United States Patent and Trademark Office

APPLICATION NO.	FILING DATE	FIRST NAMED INVENTOR	ATTORNEY DOCKET NO.	CONFIRMATION NO.
10/617,941	07/11/2003	Thomas J. Gretz	1633(Arl)	3975
30010	7590 06/11/2004		EXAMINER	
AUZVILLE JACKSON, JR.			SCHULTERBRANDT, KOFI A	
8652 RIO GRANDE ROAD RICHMOND, VA 23229			ART UNIT	PAPER NUMBER
ideimen,			3632	
			DATE MAILED: 06/11/2004

DETAILED ACTION

This first Office Action is in response to Applicant's originally filed Application received in the Office on July 11, 2003.

Continuation of Attachment(s) 6). Other: Two marked up copies of U.S. Patent No. 1,472,955 (Figures 1-4) .

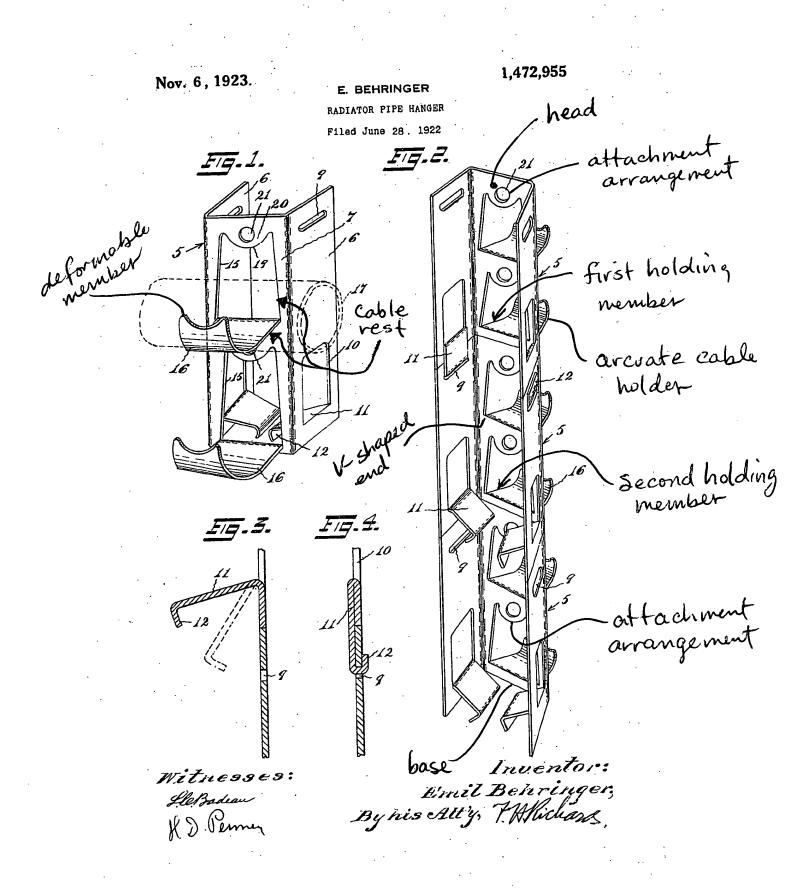
Claims 1, 2, 5, 6, 14, 15, 17 and 18 are rejected under 35 U.S.C. 102(b) as being anticipated by Behringer (1,472,955). Behringer teaches each feature of the claimed invention as shown in the attached marked-up copy of Behringer's Figures 1-4.

Claim 7 is rejected under 35 U.S.C. 103(a) as being unpatentable over Behringer (1,472,955). Behringer teaches, substantially, each feature of the claimed invention. Behringer does not teach a cable holder with between 260 and 280 degrees of arc. It would have however been obvious to one of ordinary skill in the art at the time of invention to have modified the curvature of Behinger's holding member to have additional arc including 260 degrees.in order to more securely accommodate a smaller pipe by bending Behinger's holding member around the smaller pipe.

CLAIM 4
